ADDENDUM

PROJECT: Bryan Health
Bryan Medical Center, West
Independence Center, New Facility
Lincoln, Nebraska

AD-2

DATE ISSUED: Friday, March 22, 2013

From Sheet	for CA use:
Drawing # A1-2G.1

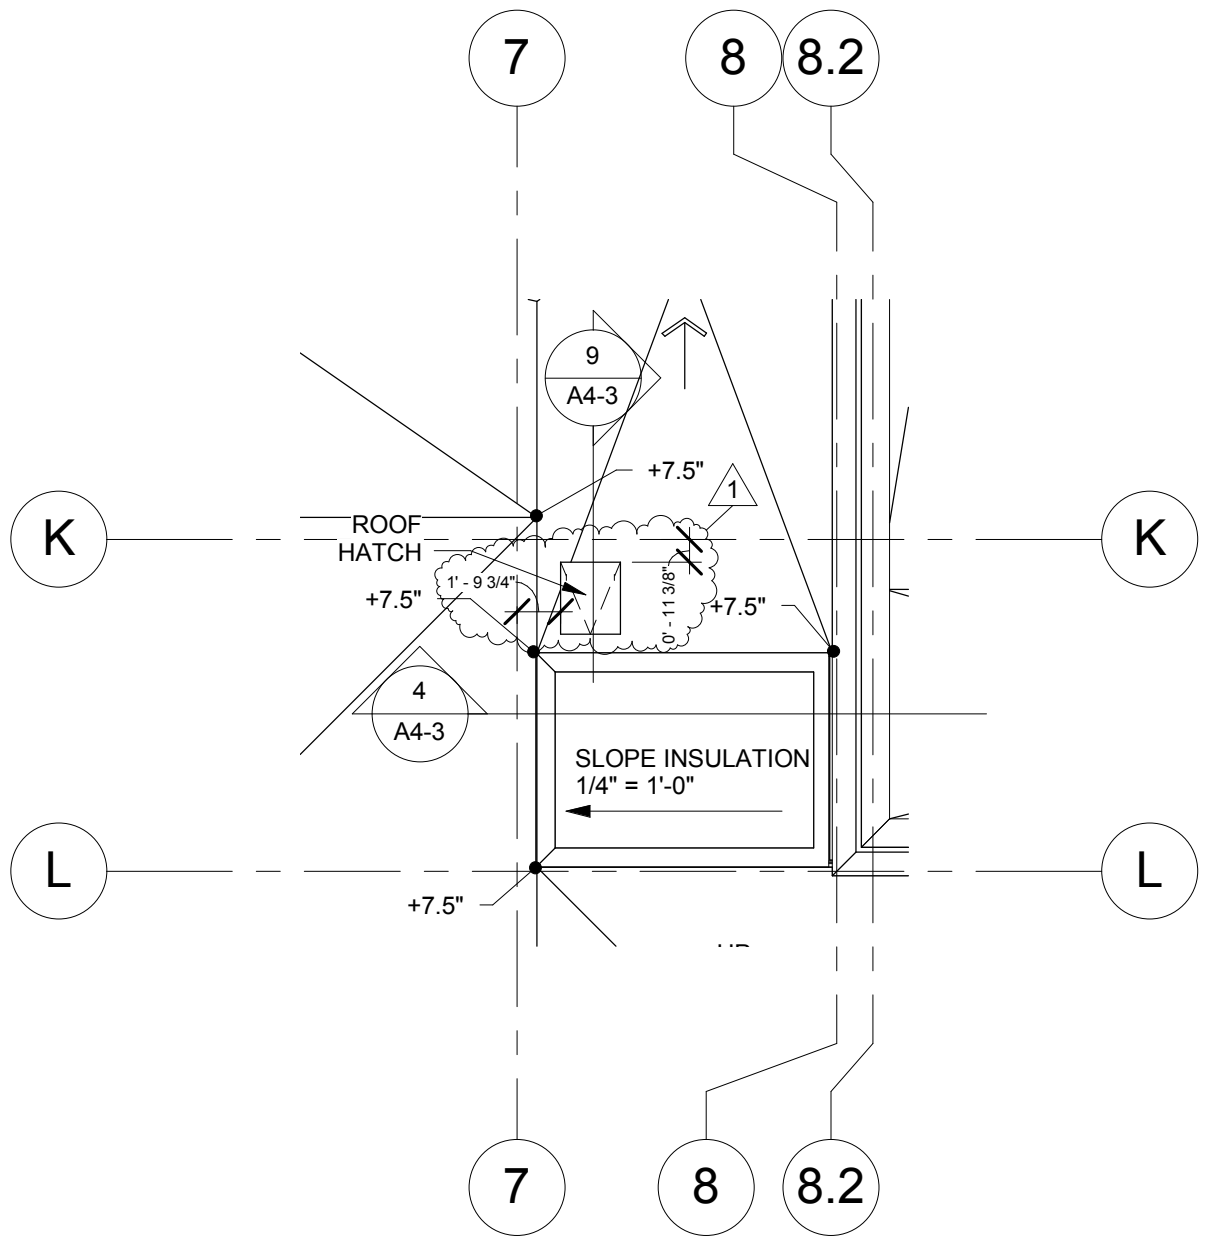
In reference to drawing sheet A1-2G – Roof Plan, see attached supplemental drawing A1-2G.1 Roof Hatch for plan revisions.

2 South Elevation
1/8" = 1'-0"

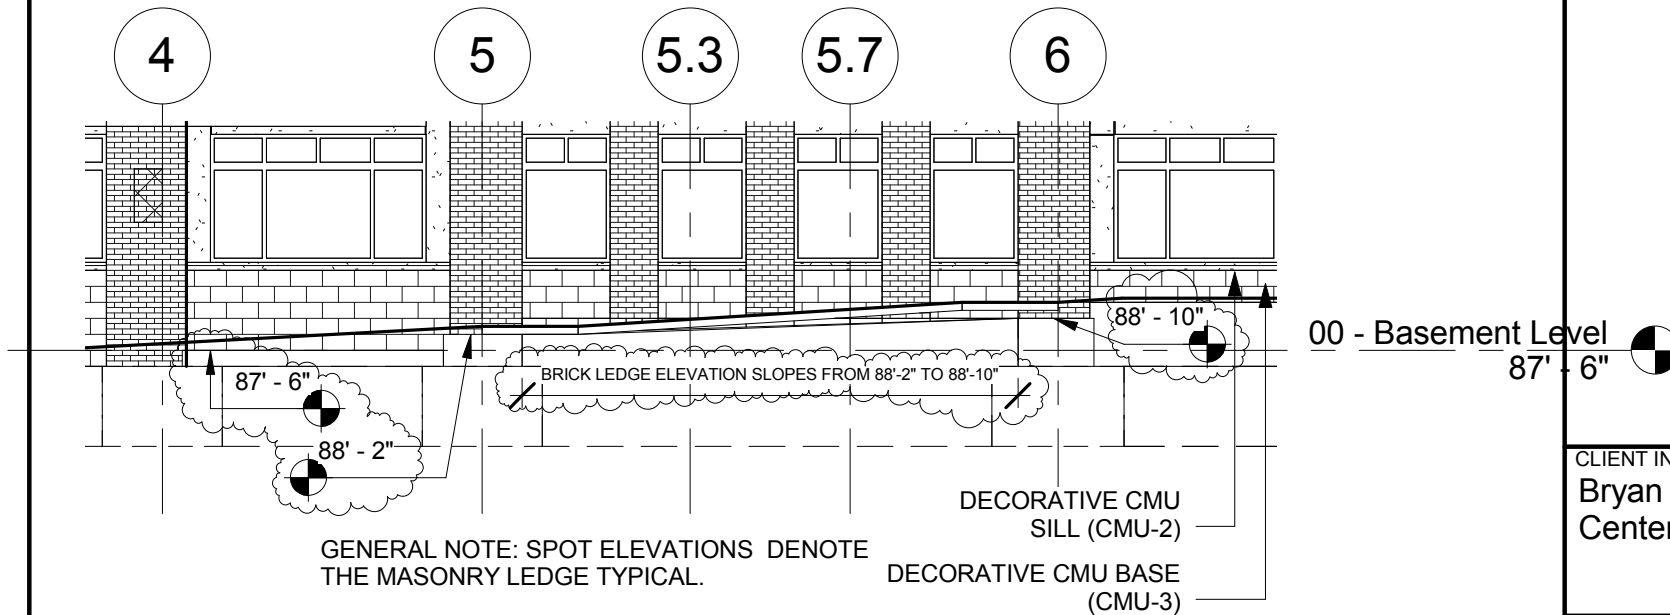
In reference to drawing sheet **A2-1 – Exterior Elevations**, revise exterior elevation 2 South Elevations as indicated in Supplemental Drawings A2-1.2 & A2-1.3 attached.

Drawing #	A3-1.1
-----------	--------

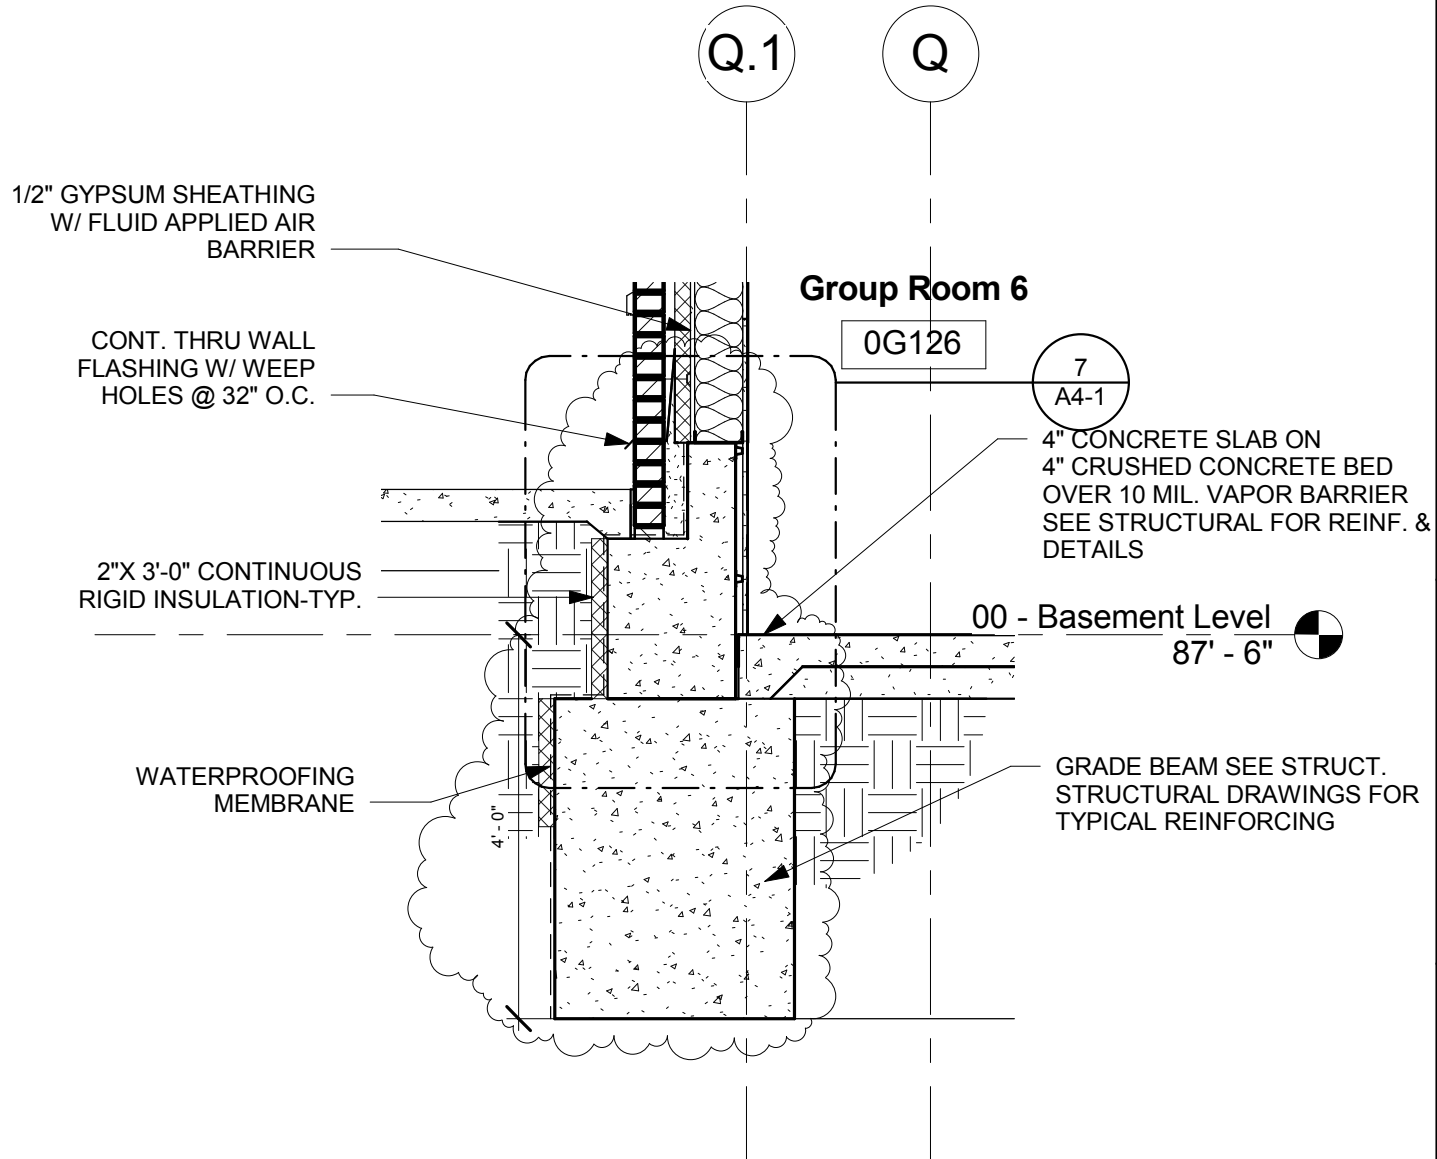
In reference to sheet **A3-1 – Building Cross Section**, revise Building Cross Section Looking North 1 as indicated in Supplemental Drawings A3-1.1 attached.

Drawing #
A4-3.1

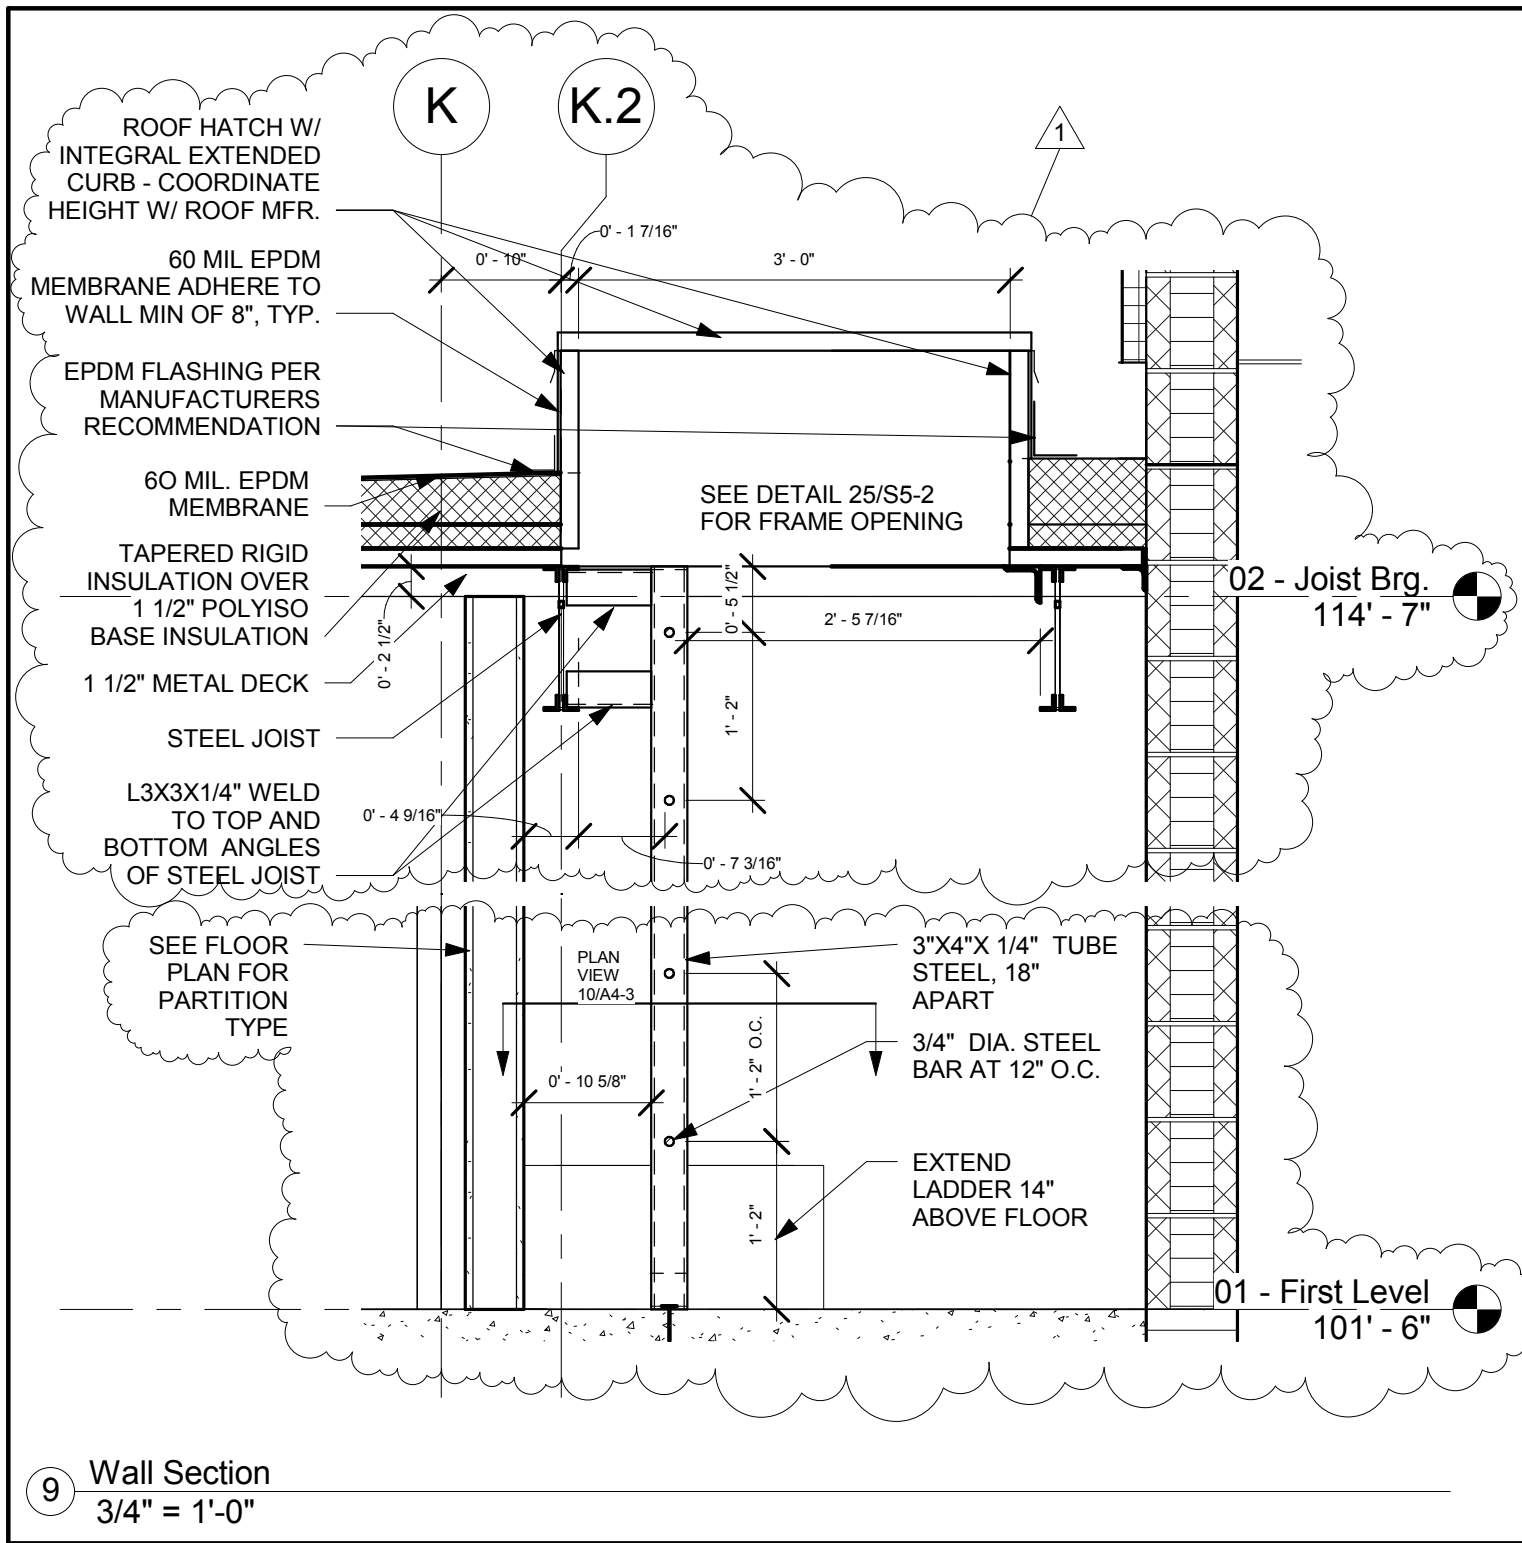
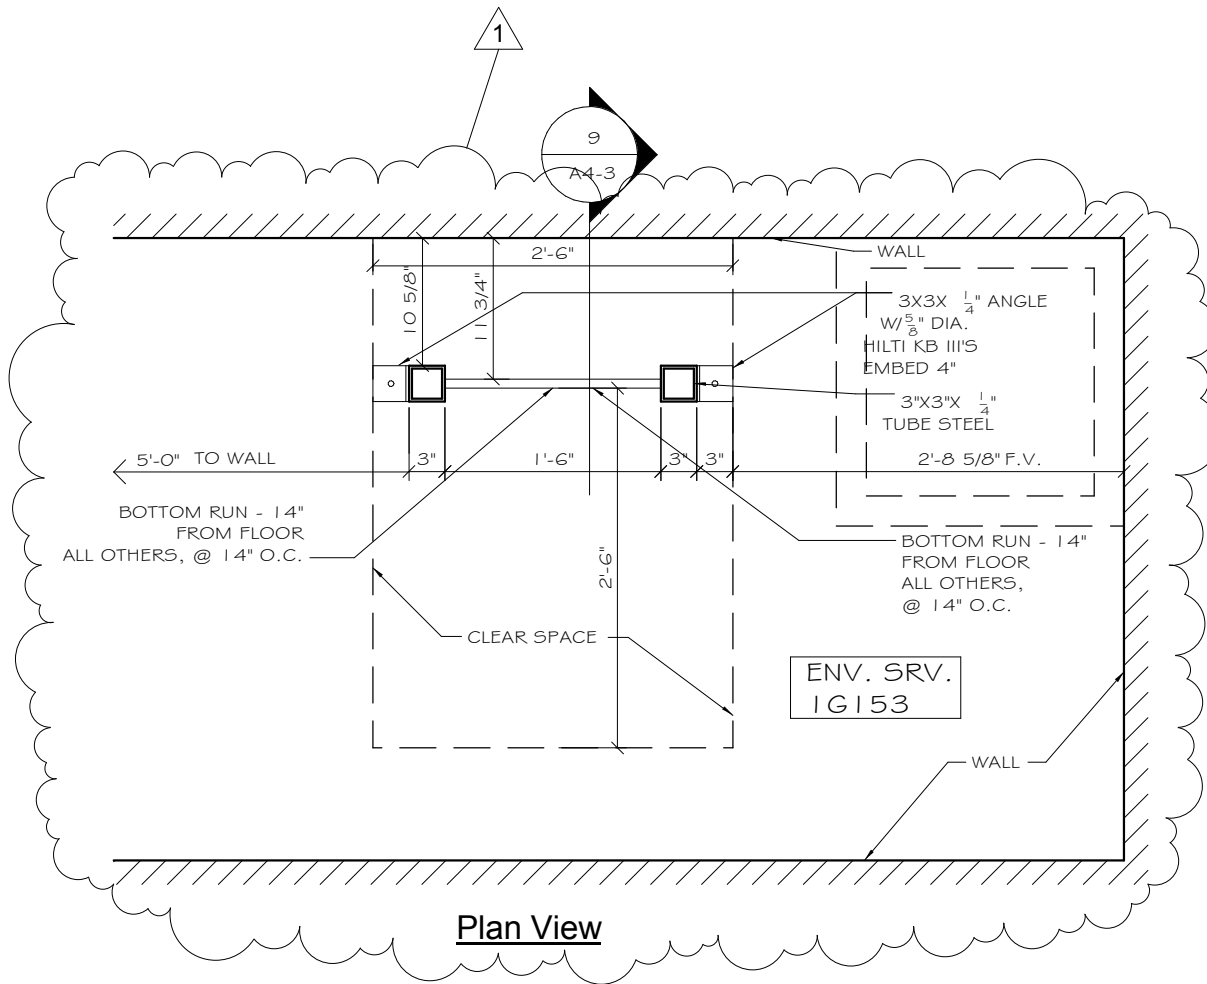
In reference to drawing sheet **A4-3 – Wall Section**, add Wall Section 9, 10 as indicated in Supplemental Drawings A4-3.1 & A4-3.2.

From Sheet	for CA use:
Drawing #	A4-6.1

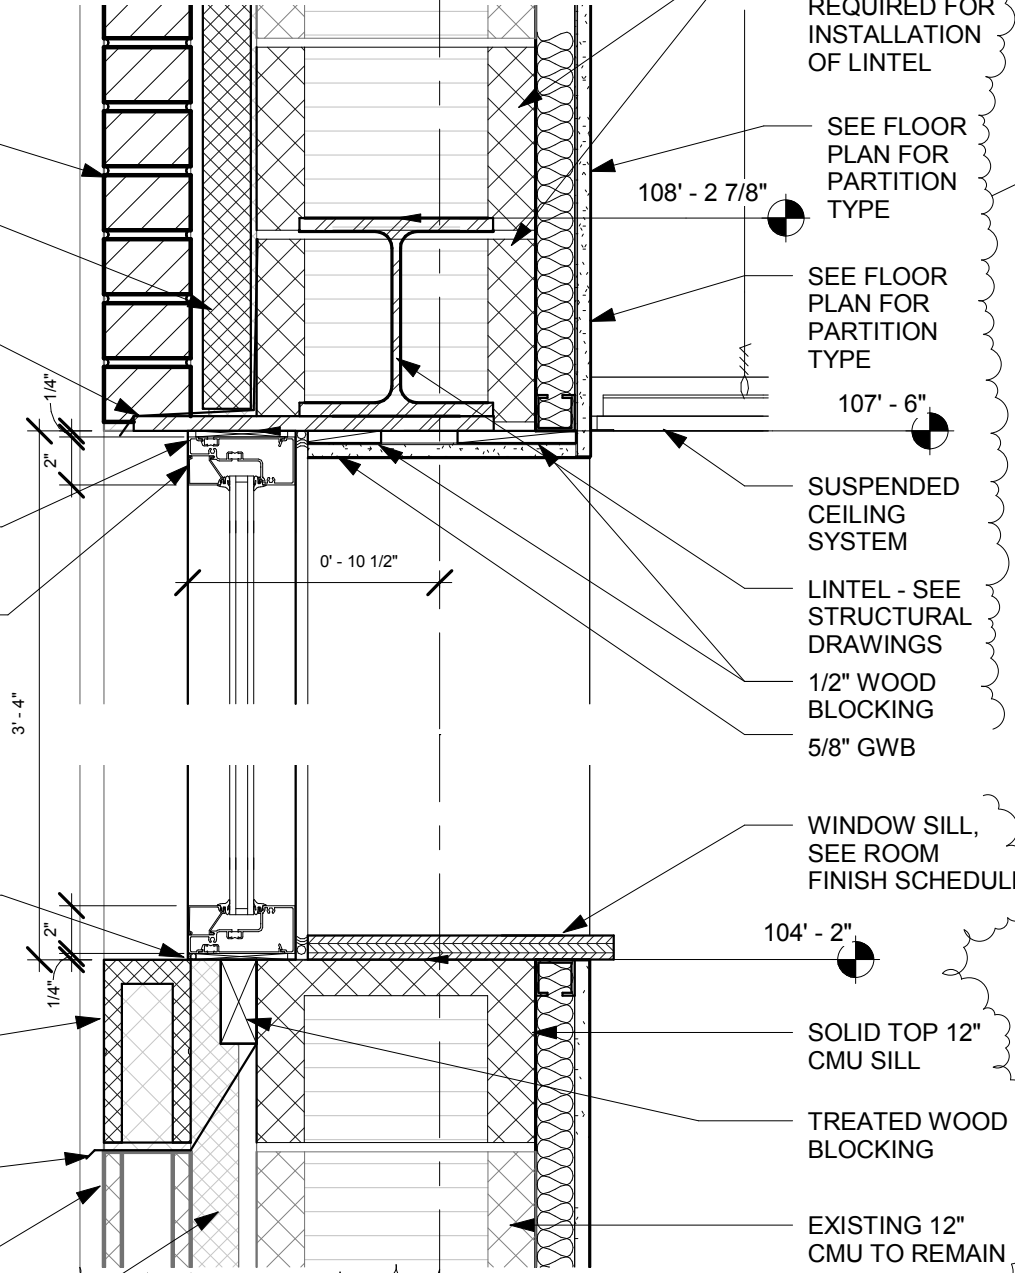
In reference to sheet **A4-6 – Section Details**, add Section Detail 11 as indicated in Supplemental Drawings A4-6.1 attached.

② IC_STAIR_AA_01
1/2" = 1'-0"

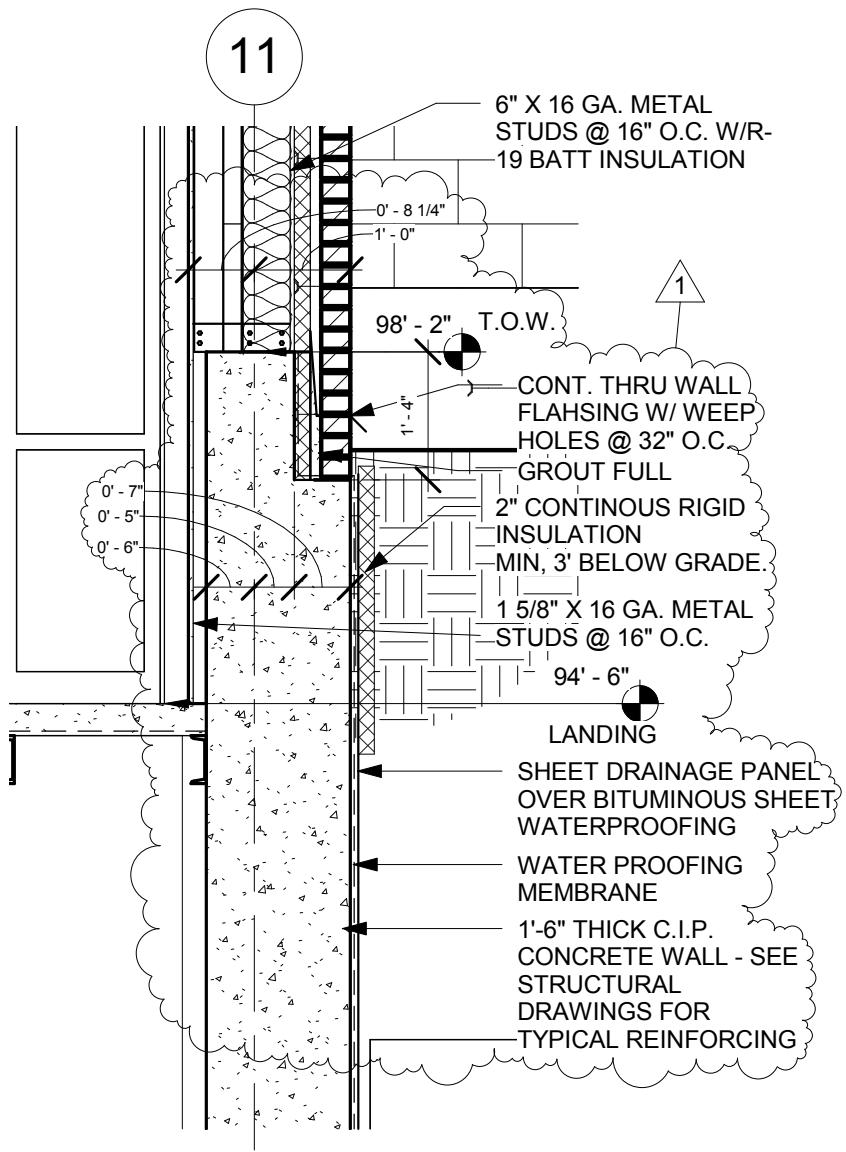
In reference to drawing sheet **A5-2 – IC Stair AA 01**, revise Section 2 as indicated in Supplemental Drawing A5-2.1 attached.
